CHIQUITA CANYON
A Waste Connections Company

Re: Chiquita Canyon, LLC – Response to LEA’s May 6, 2026 Comments on the Revised Comprehensive Global Stability Study Work Plan

Chiquita Canyon, LLC Response to Dr. Stark's April 19, 2026 Letter

FIG. 2 Shear Strength of MSW

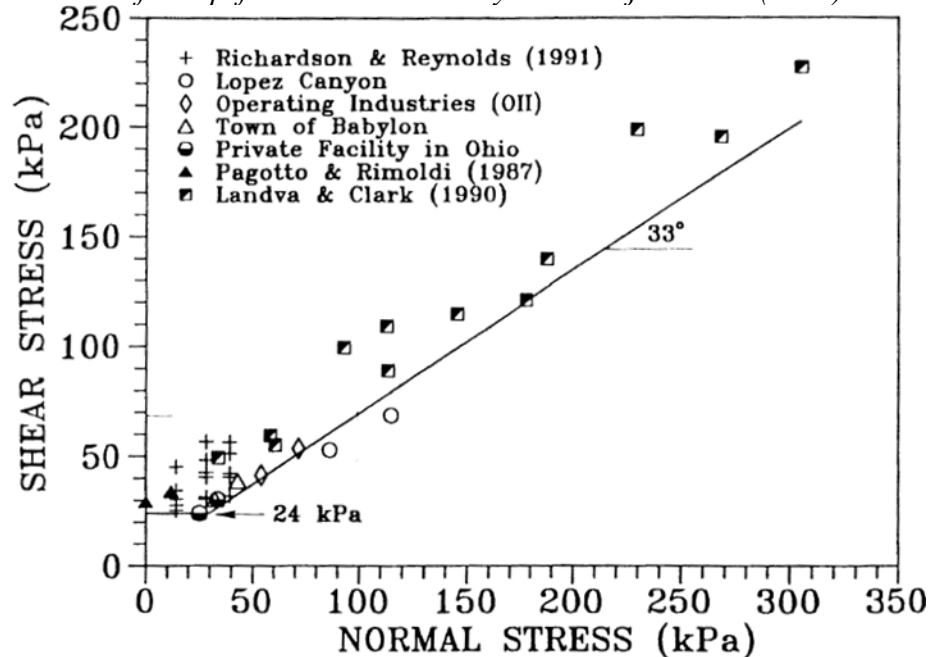
Kavazanjian et al. (1995) suggest the following effective stress shear strength parameters for MSW: cohesion (c') of 500 psf (24 kPa) and friction angle (ϕ) of 0 degrees for normal stress range of 0 to 30 kPa and $c' = 0$ and $\phi = 33$ degrees for normal stress range of 30 to 300 kPa as shown in Figure 2 below from Kavazanjian et al. (1995). The use of a c' of 500 psf (24 kPa) at low stress has a significant influence on the calculated factor of safety (FoS). If GLA continues to insist on using the strength parameters in Kavazanjian et al. (1995), it is recommended the FoS also be computed using the MSW shear strength parameters provided by Huvaj and Stark (2008) and Stark et al. (2009), which are based on failed landfill slopes.

The stress-dependent MSW strength parameters recommended by Stark et al. (2009) are:

$$0 \leq \text{Normal stress} \leq 4,200 \text{ psf} \quad c' = 125 \text{ psf and } \phi' = 35^\circ \quad \text{Normal stress} \geq 4,200 \text{ psf}$$
$$c' = 625 \text{ psf and } \phi' = 30^\circ$$

Huvaj and Stark (2008) and Stark et al. (2009) only allow a c' of 125 psf at low normal stresses instead of 500 psf as recommended by Kavazanjian et al. (1995).

No analyses performed by GLA to date have used the Kavazanjian et al. (1995) strength model. Accordingly, the basis for Dr. Stark's statement that GLA "continues to insist" on using that strength model is unclear. GLA uses the Kavazanjian et al. (2013) strength model for non-degraded waste. That model was published after the Stark et al. (2009) model and is based on a larger dataset than was available when Stark et al. (2009) was published. In GLA's opinion, the Kavazanjian et al. (2013) model is more representative of intact MSW. Previous GLA analyses have explicitly included Dr. Stark's recommendation for degraded waste and will continue to do so in future analyses.
